ADDENDUM 2

Jefferson Twp. LSD-HS Ag Ed Facility

Jefferson Township Local School District
2625 South Union Road
Dayton, OH 45417

Comm. No. 2024006.01

POWER PLANS
- BARN AND
GREENHOUSE

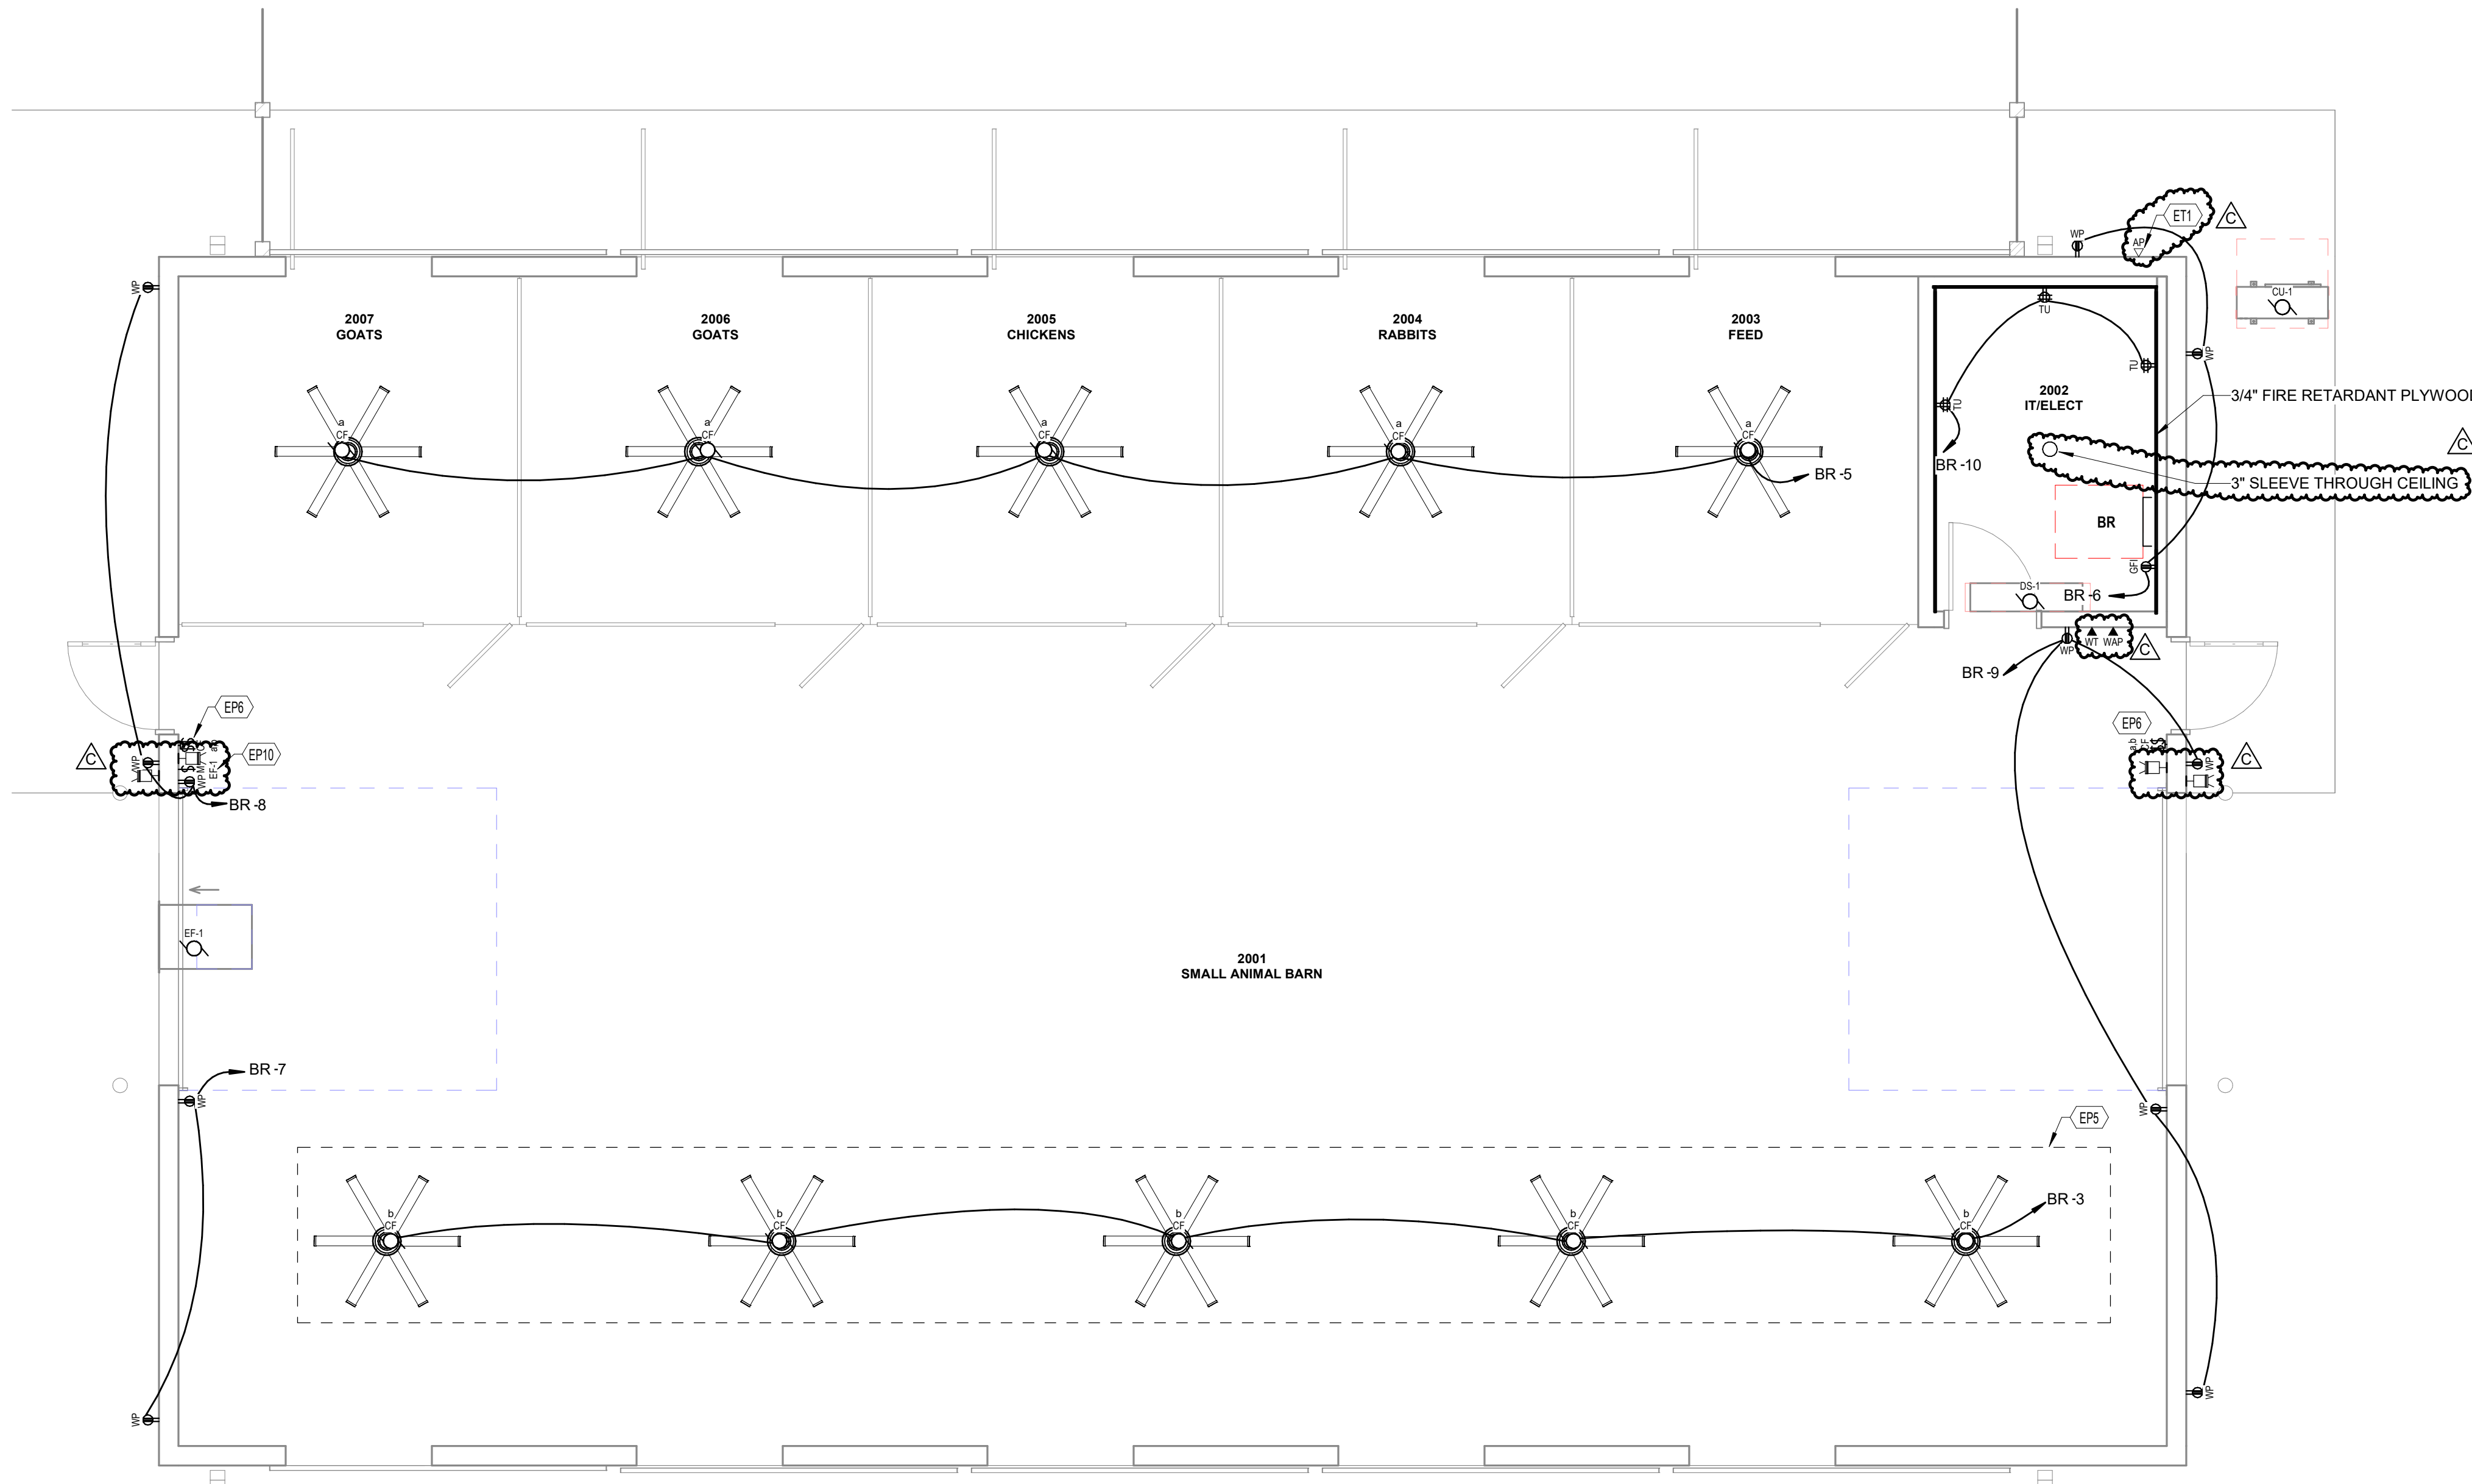
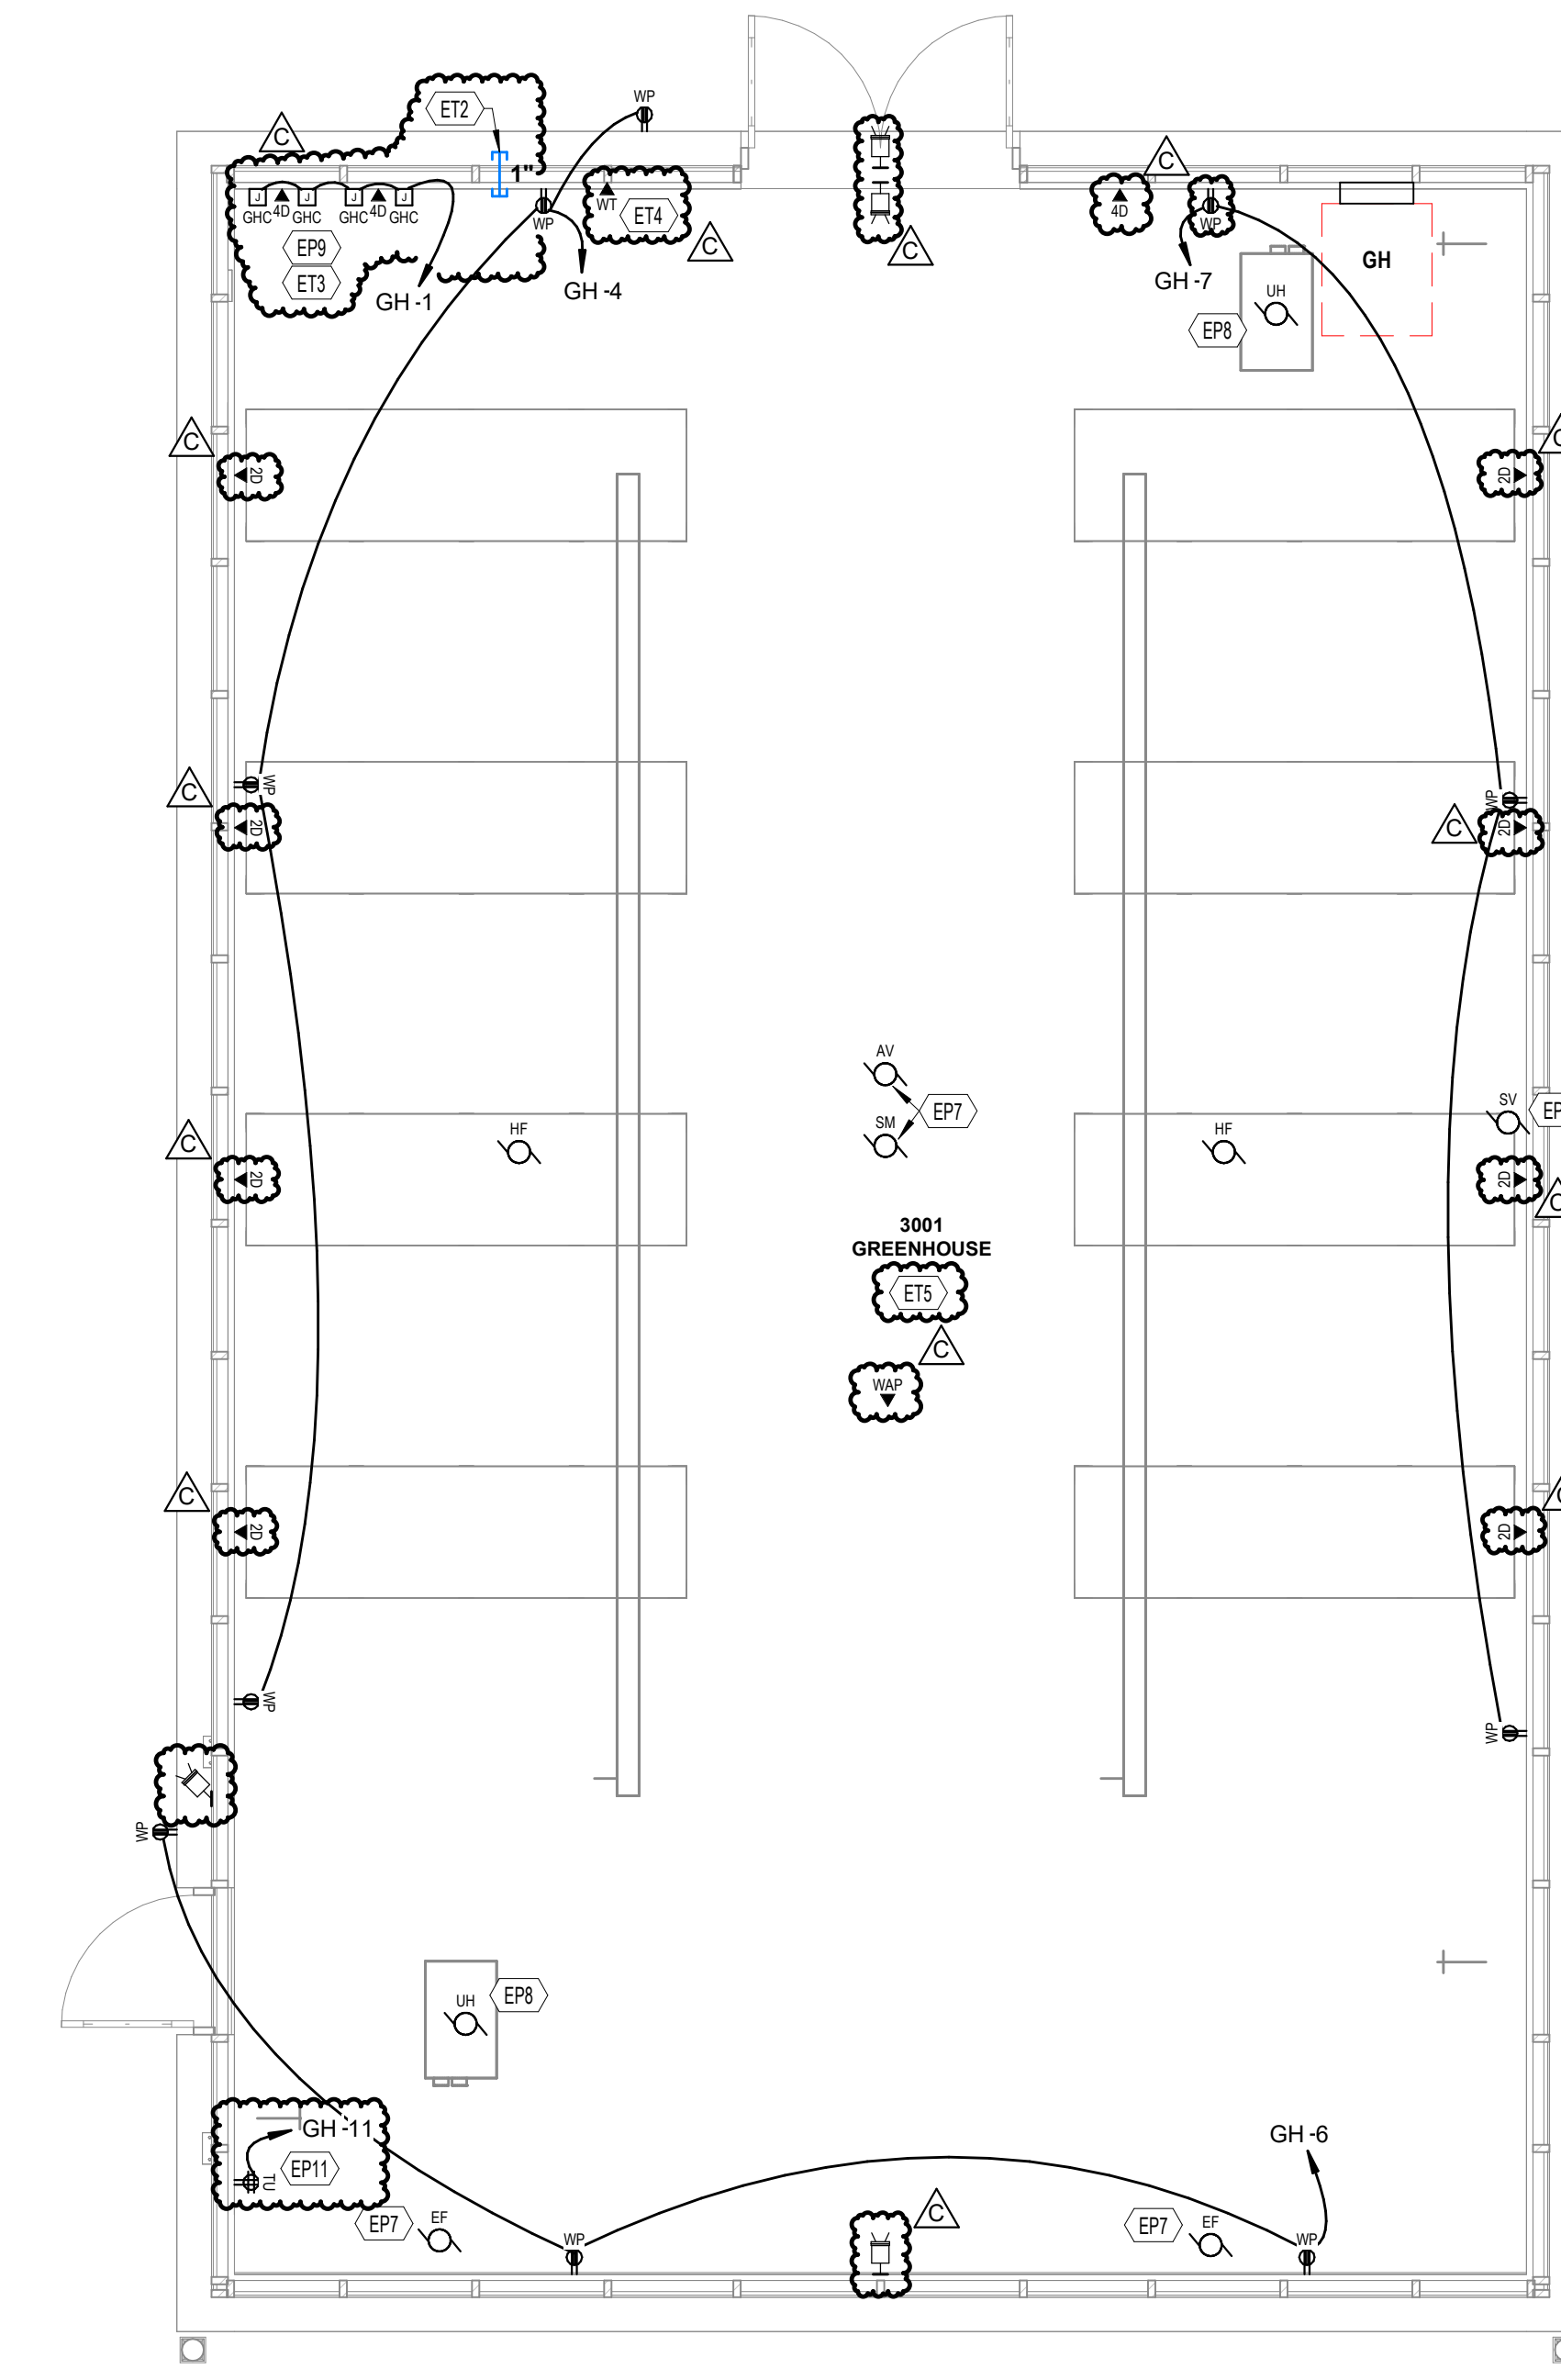
ITEM 5 – Drawing Sheet E201 - POWER PLANS - BARN AND GREENHOUSE:

- A. Revision. Delete Sheet E201 - POWER PLANS - BARN AND GREENHOUSE and replace with attached Sheet E201 - POWER PLANS - BARN AND GREENHOUSE.
1. Added General Technology Notes.
 2. Added security cameras, wall telephones, and wireless access points to the Barn and Greenhouse.
 3. Added sleeve ceiling to 2002 IT/ELECT in Barn.
 4. Added sleeves for future use to Barn and Greenhouse.
 5. Added data for greenhouse controllers and work tables.
 6. Revised receptacle location and added data for future POS station in the greenhouse
 7. Added tech enclosure receptacle.

1 ELECTRICAL SITE PLAN
 E700 1" = 20'-0"

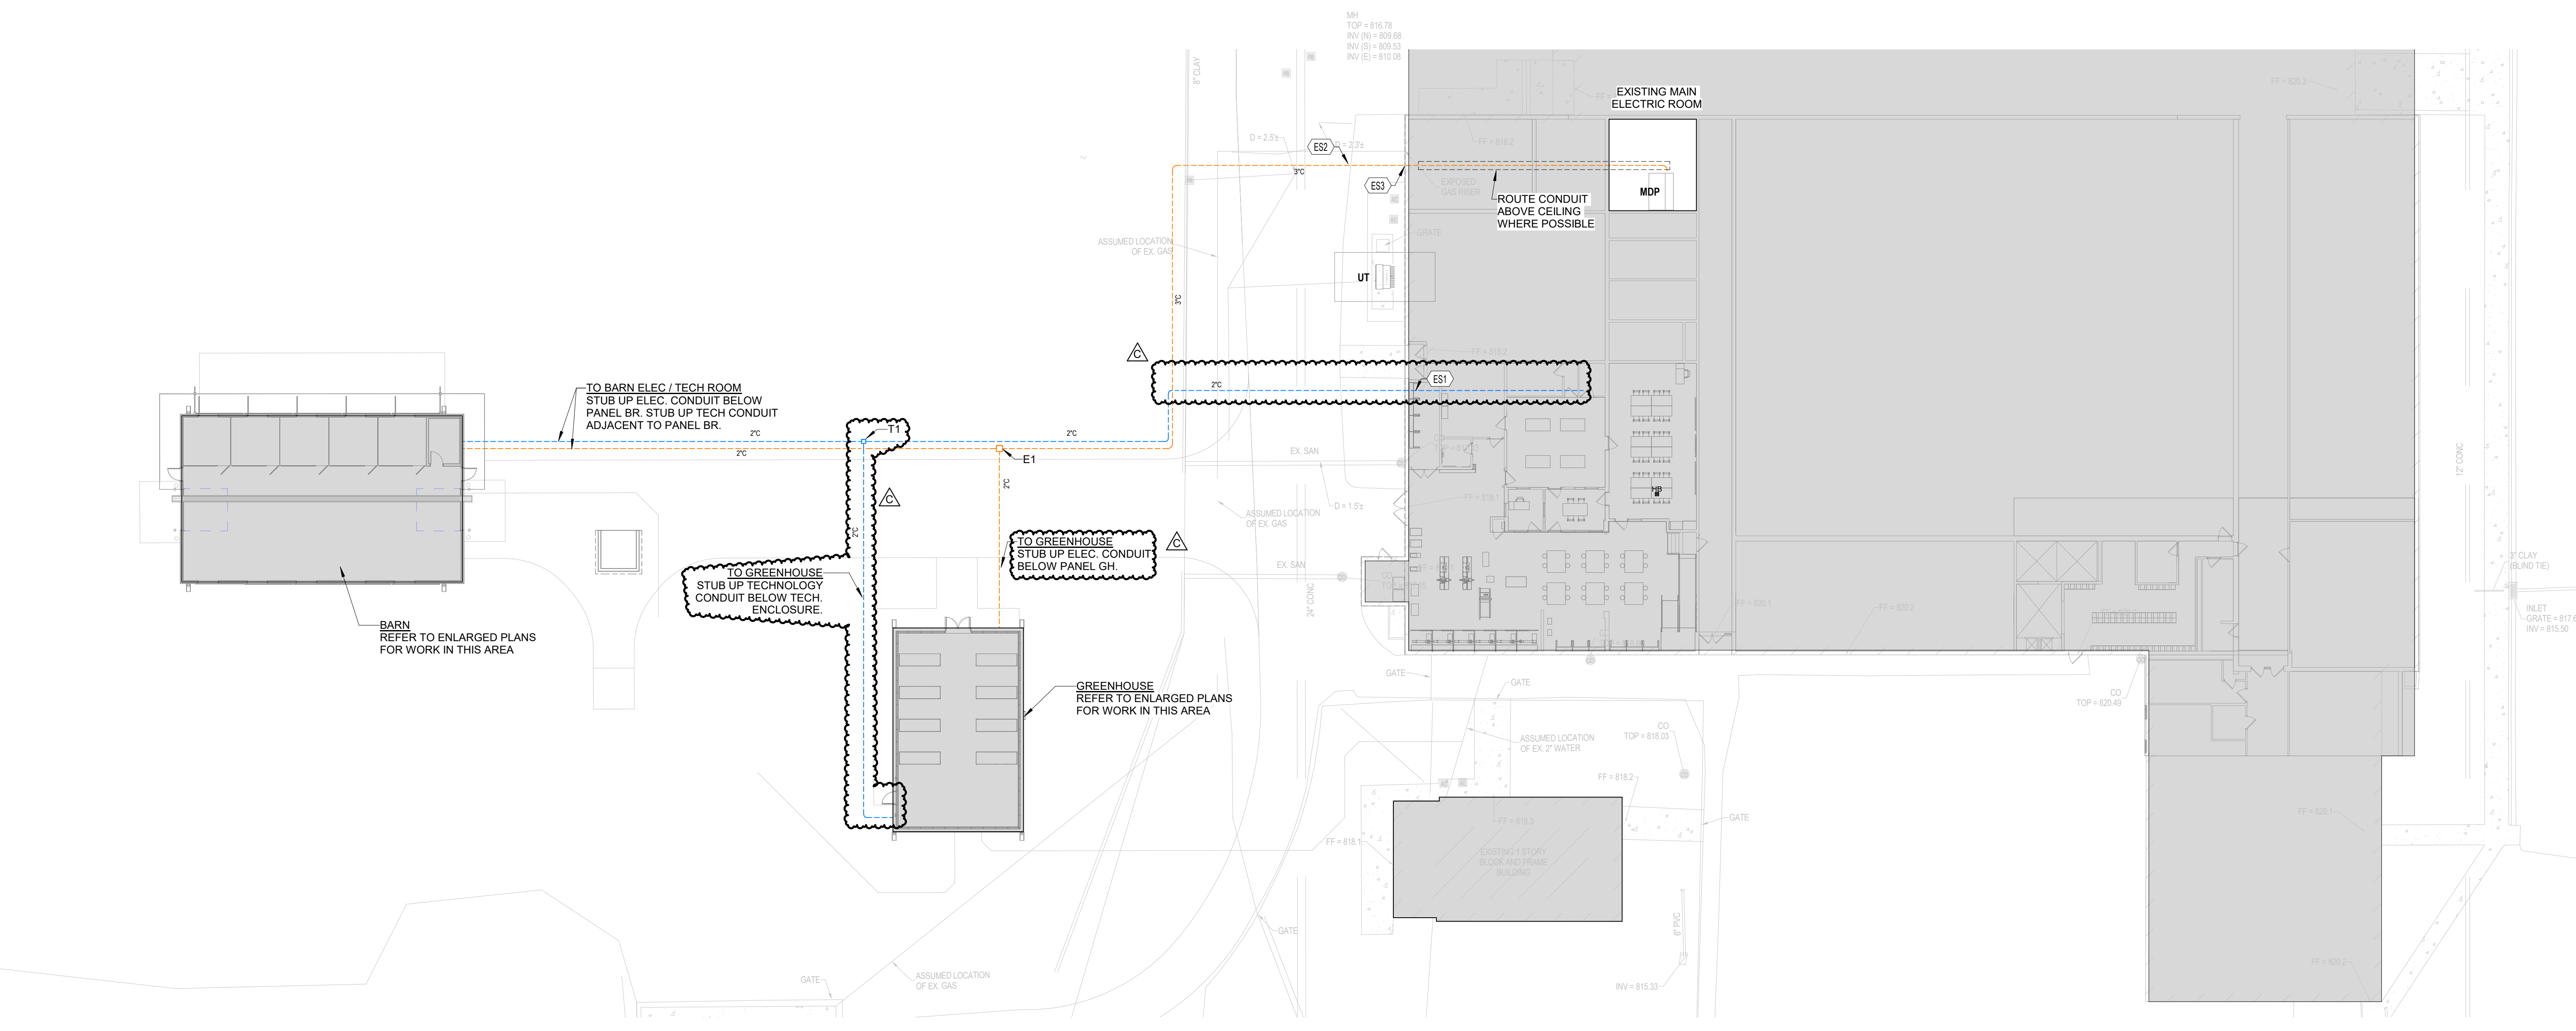
ITEM 7 – Drawing Sheet E700 - ELECTRICAL SITE PLAN:

- A. Revision. Delete Sheet E700 - ELECTRICAL SITE PLAN and replace with attached Sheet E700 - ELECTRICAL SITE PLAN.
1. Revised routing of tech conduit to go to new IT room, and tech enclosure in the greenhouse.
 2. Revised keynotes to clarify conduit routing.
